## PLANNING REPORT

# Architectural Review Board

## 16 N High Street 25-023INF

Address	16 N High Street
Proposal	Modifications to a Landmark building and associated site improvements on a 0.26-acre site.
Request	Informal Review and feedback for building and site modifications.
Zoning	HD-HC, Historic Core District
Planning Recommendation	<u>Consideration of the discussion questions.</u>
Next Steps	Upon receiving feedback from the Architectural Review Board (ARB), the applicant may incorporate the feedback and submit for Minor Project Review (MPR).
Applicant	Paige Fleming, Tim Lai ArchitecT
Case Manager	Rati Singh, Assoc. AIA, Planner I (614) 410-4533 <a href="mailto:rsingh@dublin.oh.us">rsingh@dublin.oh.us</a>

Site Plan

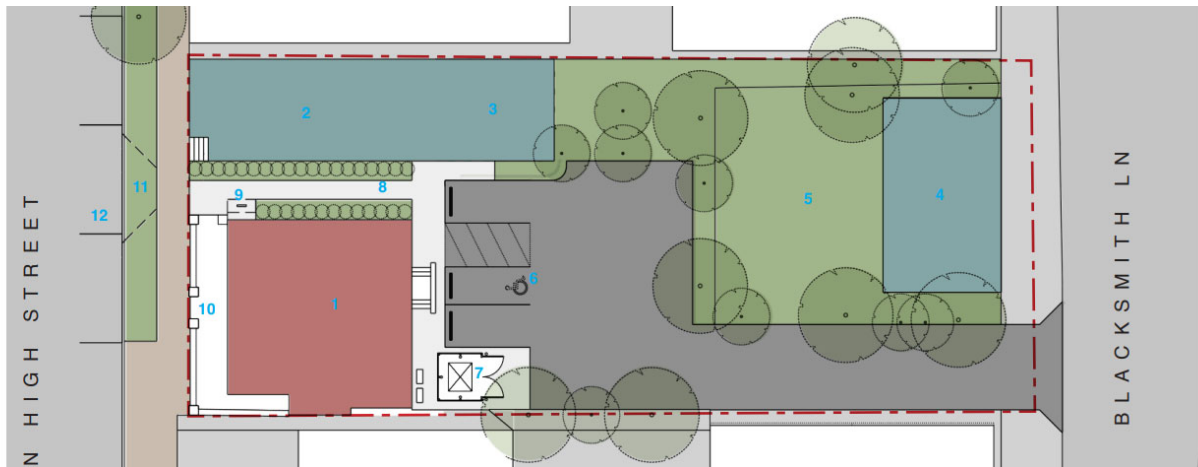
The applicant plans to replace the asphalt driveway between the existing buildings with a pedestrian walkway to create a corridor for pedestrians from N. High Street to the rear of the site, enhanced by foundation plantings on both sides. The Board supported this proposal at previous meetings.

Additionally, the applicant intends to remove the existing curb cut along with the surrounding conditions and replace them with a seeded or grassed tree lawn, a curb along the right-of-way, and a brick paver sidewalk. If on-street parking spaces can take the place of the current curb cut, a striping and signing plan will need to be provided in the next step.

The applicant also proposes to resurface the existing driveway at the rear of the property and restripe the parking lot with a required ADA parking spot. The goal is to preserve the maximum number of trees, to be evaluated at MPR.

The applicant also proposes to clean the existing outbuilding facing Blacksmith Lane and enclose it with painted Hardie Board panels. The applicant will need to work on the panel details and design to ensure that it fits within the district's character.

The applicant proposes to add a 6-foot tall, 10-foot by 10-foot dumpster enclosure at the rear of the building. Staff has concerns regarding both the size and location of the dumpster, as it is positioned directly facing the entry drive; it also appears to be oversized. The code requires the materials and design of the fencing surrounding the dumpster to match the nearest wall of the principal structure. The applicant will need to provide these design details in the next steps.

Staff has identified several inappropriate, unapproved HVAC unit installations on the north façade of the building. The applicant has agreed to remove these installations and restore the façade to its original state. To preserve the historic character of the District, staff recommends that these installations be removed as soon as possible. Staff will need to know if penetrations were made into the historic rock façade, and if so, what appropriate measures will be taken for restoration.

A new Type 2 exhaust hood is required for the restaurant use. Per Code, all roof-mounted mechanical equipment must be completely screened from view at ground level on all sides of the structure. To comply with these regulations and the requirements set by Building Standards, a 9' x 9' enclosure is proposed, rising to 2'6" above the ridge on top of the gabled roof. This screening will not be visible from a straight-on view across N. High Street, but will be seen upon approach from N. Blacksmith Lane. The applicant plans to paint the screen to match the gray color of the standing seam roof.

The *Historic Design Guidelines* recommend that rooftop equipment and ventilation systems be centrally located and fully screened from view using primary building materials. Additionally, roof penetrations should be painted to match the roof. The applicant needs to further address these points and any alternatives in the next stage of the process.
